**CITY OF MOUNTAIN VIEW
MEMORANDUM**

SUBJECT: MAY 25, 2010 STUDY SESSION—HIGH-SPEED RAIL ALTERNATIVES ANALYSIS

The purpose of this Study Session is to gain Council input on proposed comments from the City to the California High-Speed Rail Authority (CHSRA) on the Preliminary Alternatives Analysis Report (AA) for the High-Speed Rail (HSR) project.

ELEVATION LOOKING NORTH FROM CASTRO OF AERIAL STRUCTURE WITH TOWERS

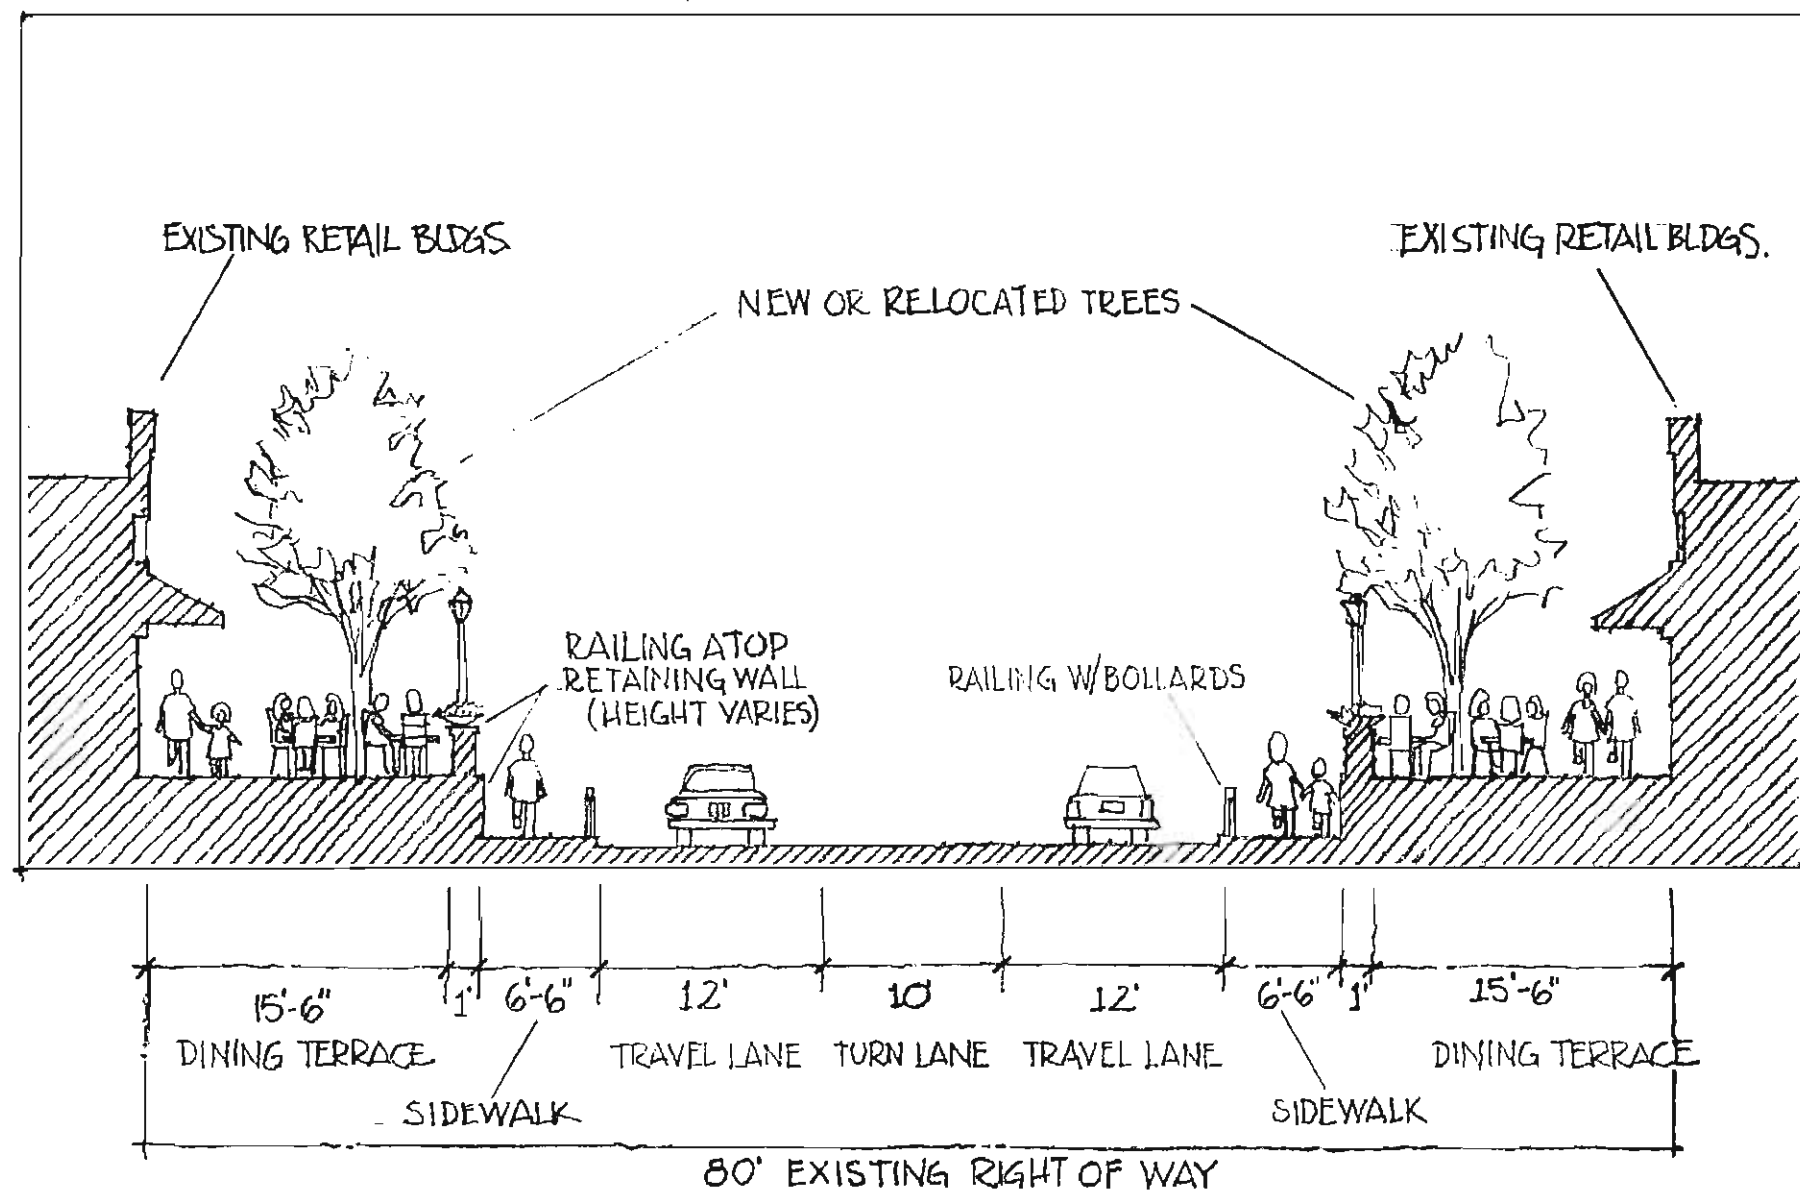
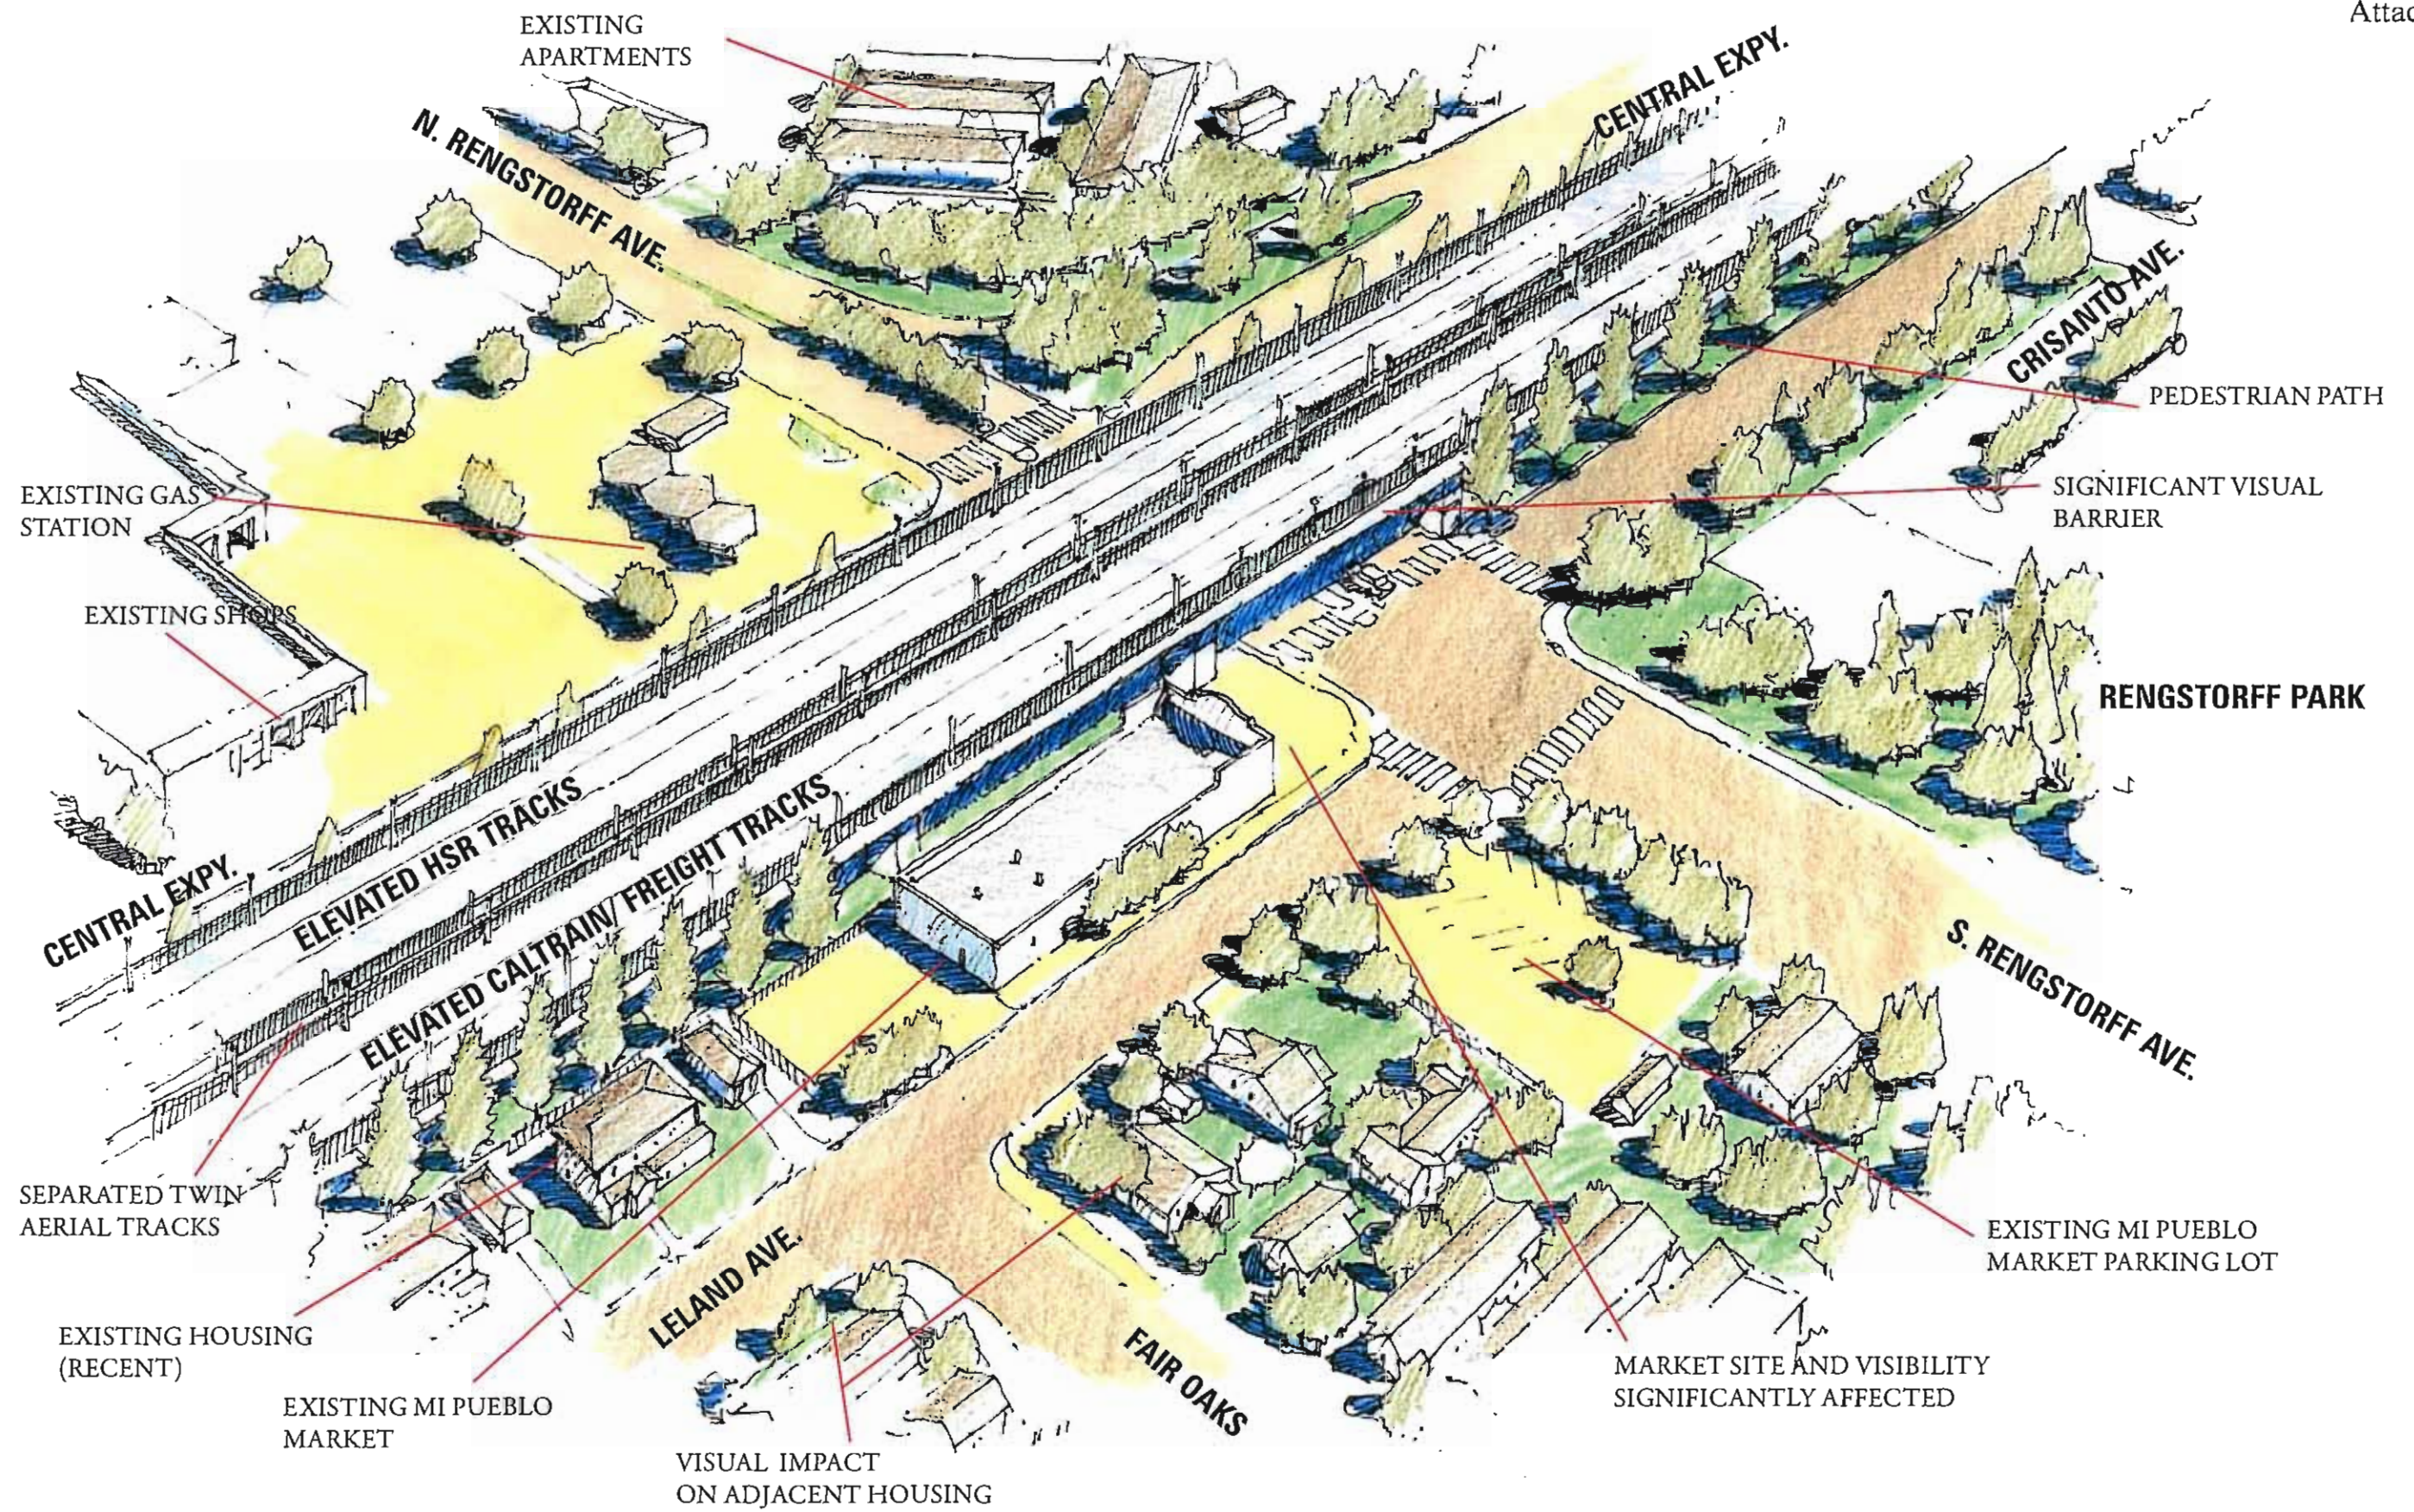
- The aerial viaduct has the greatest negative visual impact on the community. While very little information about the detailed design of an elevated structure was available in the AA, enough was provided to indicate that the size and scale of structure required to elevate the HSR/Caltrain/freight rails is akin to an elevated freeway structure bisecting the City and would dramatically change the view along the entire corridor. The FTS cross section of Castro Street with the aerial

structure in the background (see Attachment 3) shows the structure behind the train depot building at Centennial Plaza and gives an idea of the size and scale of the structure viewed from Castro Street.
